Productinformatie - Remblokken | HELLA

Remblokken

8DB 355 011-401/8DB 355 015-961

Gemodificeerde remblokken

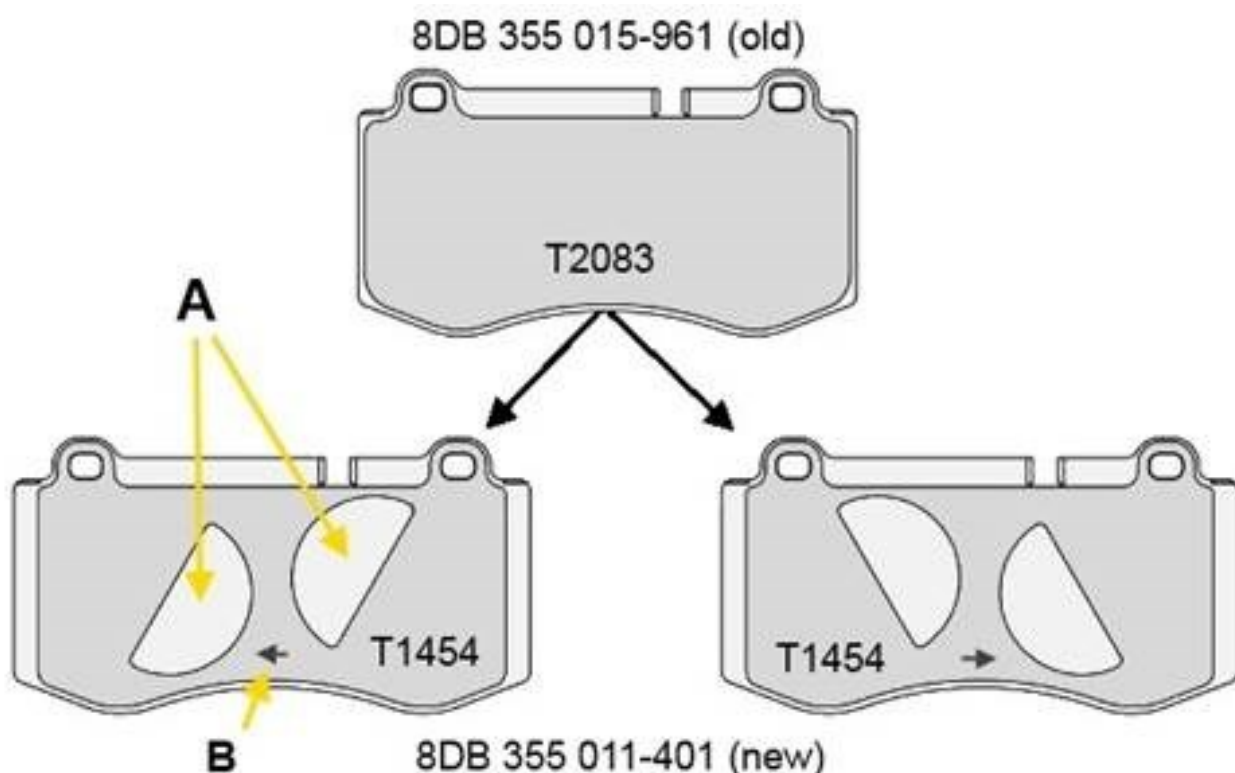
Wegens enkele veranderingen in de serieproductie is ons productassortiment als volgt aangepast:

Remblok 8DB 355 015-961/T2083 is vervangen door remblok 8DB 355 011-401/T1454.

Het verschil tussen de twee remblokken is een modificatie van de dempingsplaat op de rugplaat van het remblok. Deze modificatie verbetert de gevoeligheid voor geluidsontwikkeling en daardoor ook de comforteigenschappen van het remblok.

De nieuwe dempingsplaten met uitsparing (A) moeten worden gemonteerd in de rijrichting. De montagerichting wordt aangegeven met een pijl (B).
